Oral Hearing into Objections to the Granting of a Waste Licence to Fingal County Council in Respect of a facility at Fingal landfill, Nevitt, Lusk, County Dublin.

Waste Licence Application W 0231-01

Submission by: EurGeol Kevin Cullen PGeo.

Figure 2 Draft Conceptual Hydrogeological Model

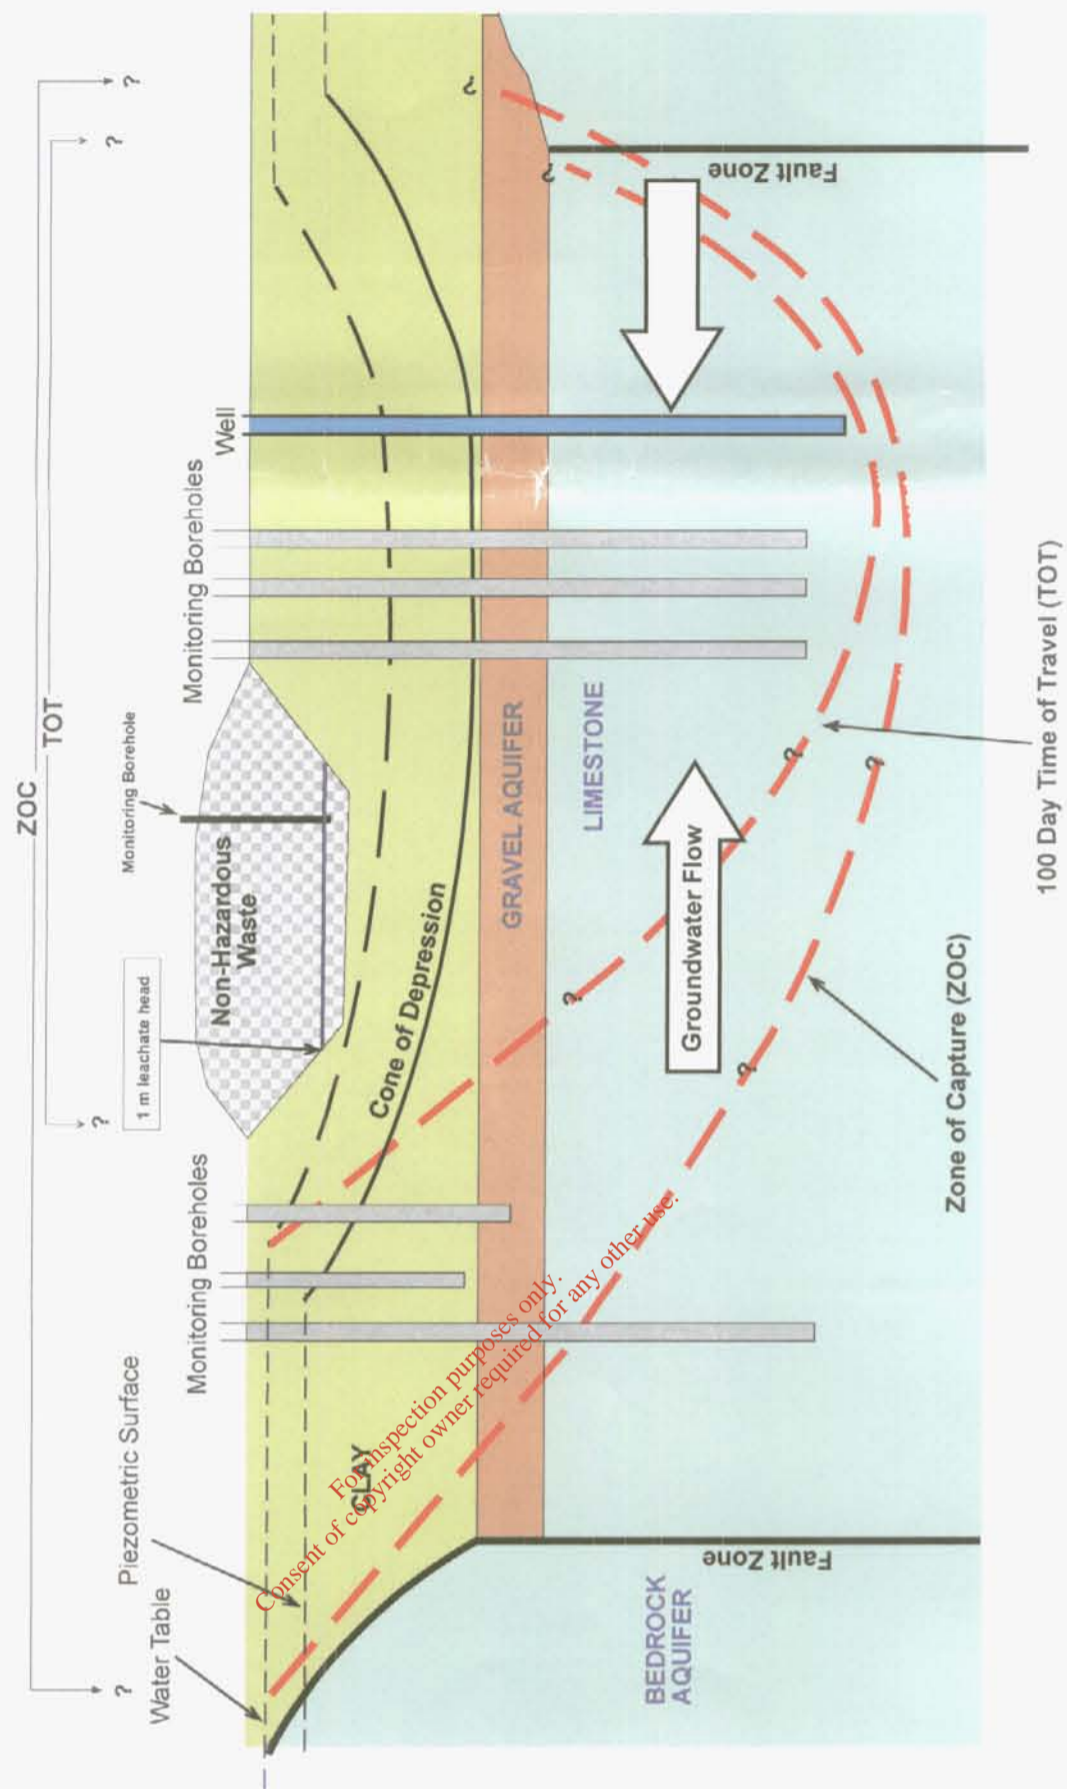
The Conceptual Site Model which is presented in the EIS (Fig. 9 of Vol. 5) underestimates the magnitude of the of groundwater resource identified beneath the landfill footprint by failing to record the;

- extent of the fault controlled bedrock trough located beneath the landfill footprint
- extent of the gravel aquifer overlying the bedrock
- the high degree of faulting recorded by the geophysical survey
- dramatic change in the piezometric surface known to exist along the south western edge of the landfill

The conceptual model presented in the EIS does not include many important geological and hydrogeological features found on the proposed development site and adjoining areas. The Draft conceptual model accompanying this submission (Figure 2) should, it is respectively suggested, now form the basis of the numerical model that was and still is required to establish the magnitude of the groundwater resource at Nevitt together with the full range of impacts associated with the development of a landfill at this location.

A draft conceptual model accompanies this submission as Figure 2.

Figure 6 N-S Cross-Section Through Proposed Landfill

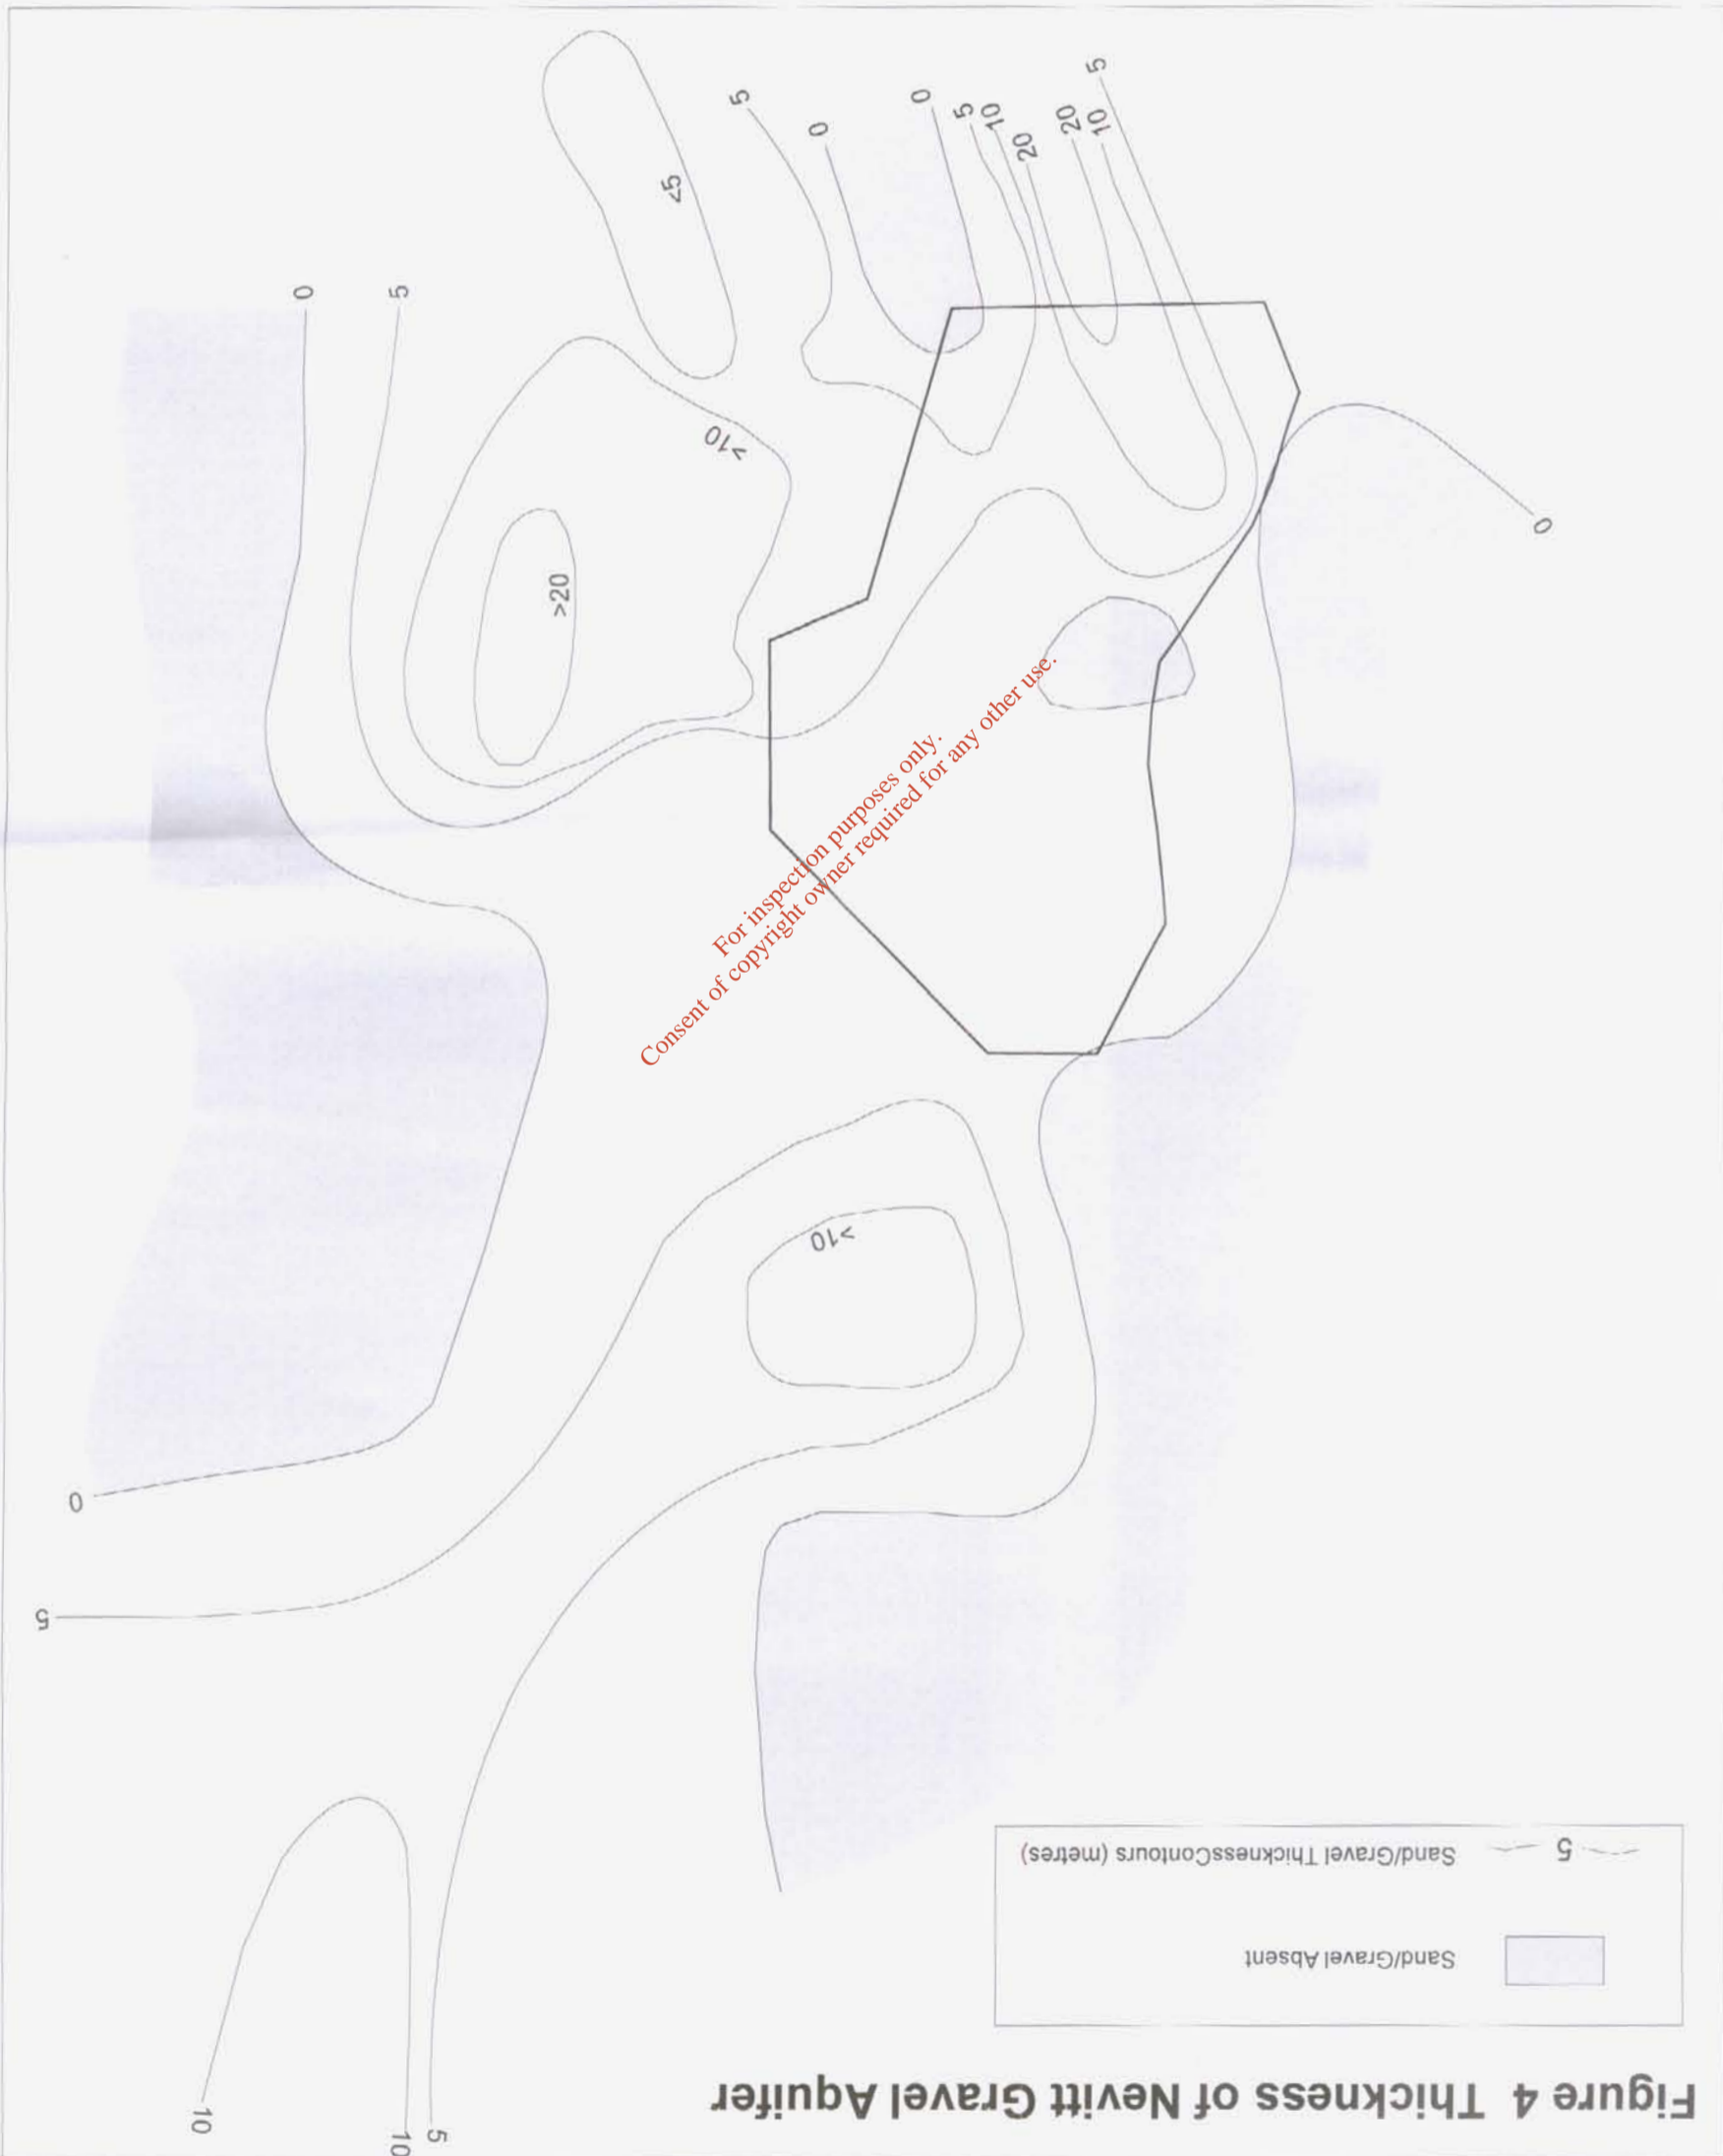
A north-south section(Figure 6) through the landfill accompanies this submission showing the continuous nature of the Nevitt gravel aquifer along the line of the section.

Figure 5 Cross-Section B-B'

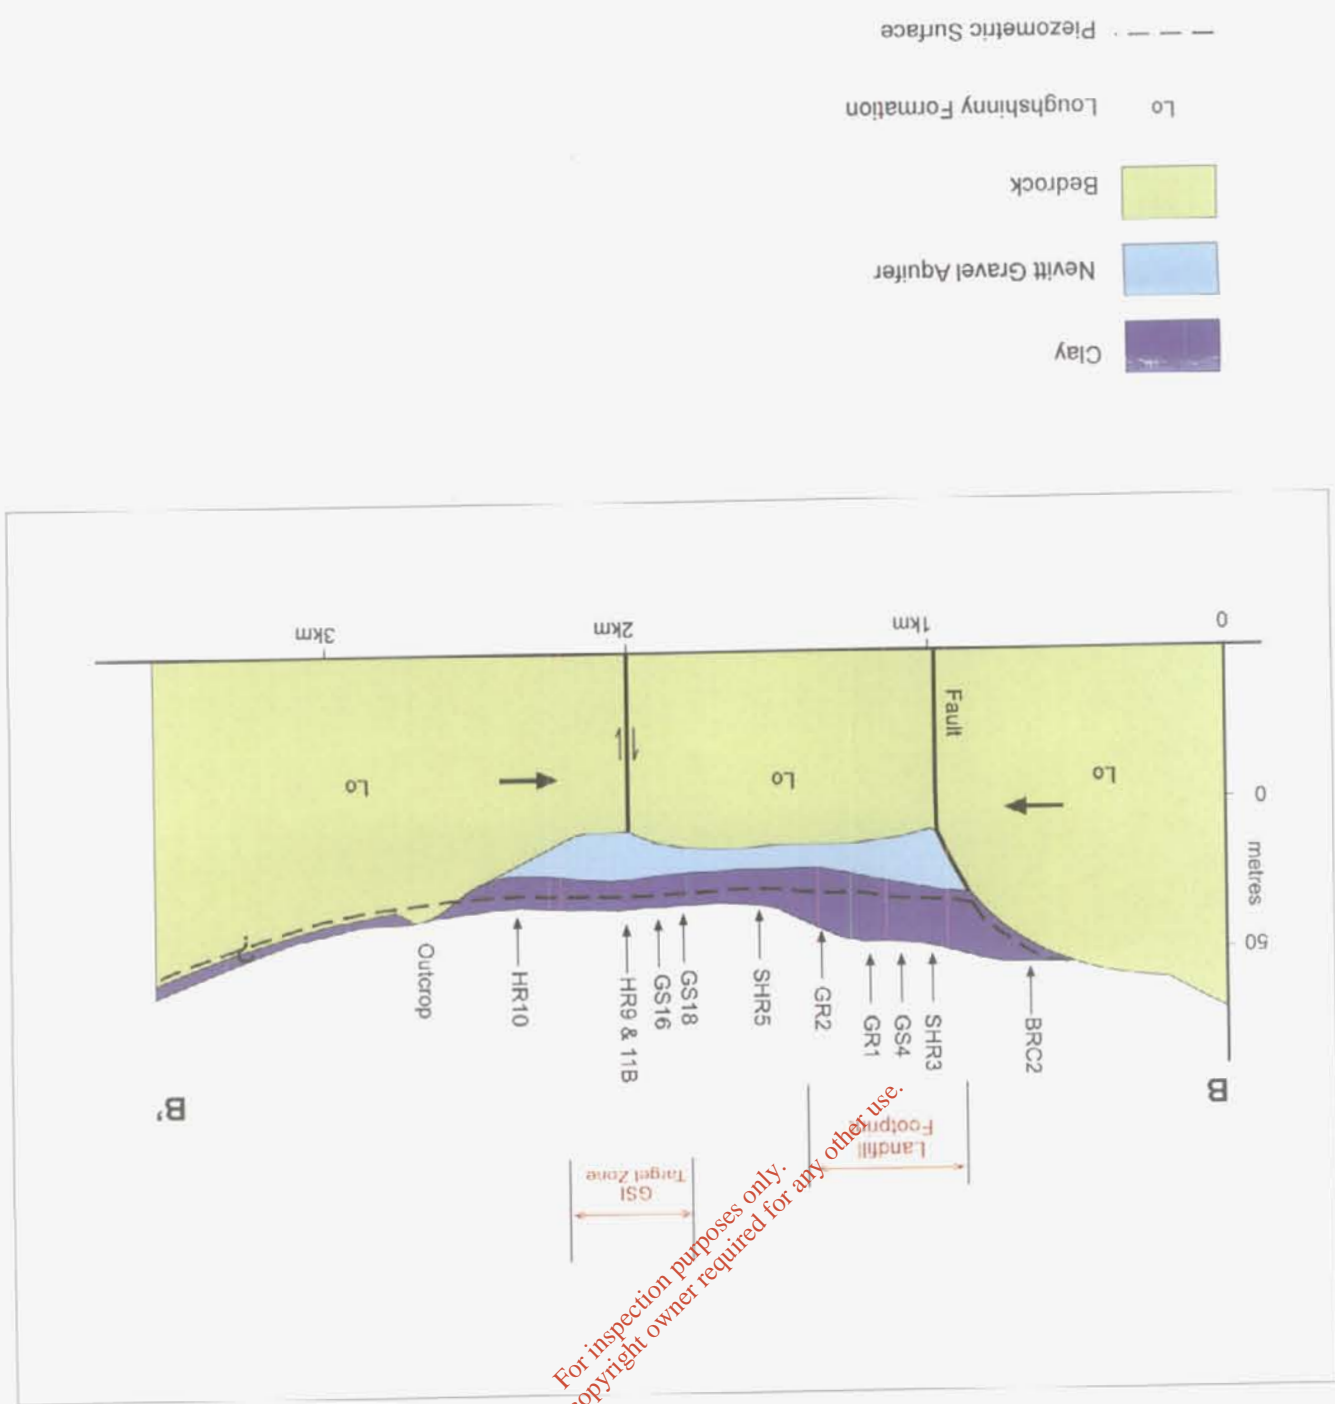
The revised cross-section submitted by the Applicant to the Agency does not correlate with either the data presented in the EIS or the additional plan maps provided by the Applicant to the Agency.

For example, it is obvious from the logs of Boreholes HR 9 and 11A that a substantial thickness of gravel occurs over the GSI fault zone along the B-B section. However, the revised cross section shows **no** gravel at this location and so the revised cross section submitted to the Agency presents a picture with a severely diminished extent and thickness of the gravel Nevitt gravel aquifer along this line of section.

The Applicants' map of the extent of the thickness of the gravel aquifer shows extensive gravel along the line the GSI fault but this picture is not shown by the Applicant's revised cross section.

The groundwater contours presented by the Applicant display a significant change in gradient immediately to the west of the footprint. This important feature is not represented on the revised cross section supplied by the Applicant.

The cross section accompanying this submission endeavors to reflect all the geological and hydrogeological information provided by the Applicant. Of particular note is the coincidence of the steep change in the bedrock piezometric surface with the western edge of the footprint. It is obvious that the change in gradient is associated with the gravel filled and fault controlled bedrock trough underlying the footprint with the change in gradient reflecting the higher permeability conditions that occur beneath the footprint.

As mentioned above the accompanying cross section shows how bedrock outcrops immediately to the east of Borehole HR 10 and which is not represented on the Applicants' cross section. This outcrop is part of a wider area of outcrop clearly shown on the GSI Sheet 16 for the area and which correlates well with the Soils Map of the area that accompanies the EIS as Figure 6 in Volume 5. The presence of rock here invalidates the Applicants suggestion that a thick layer of clay is to be found overlying the bedrock to the east of Borehole HR 10.
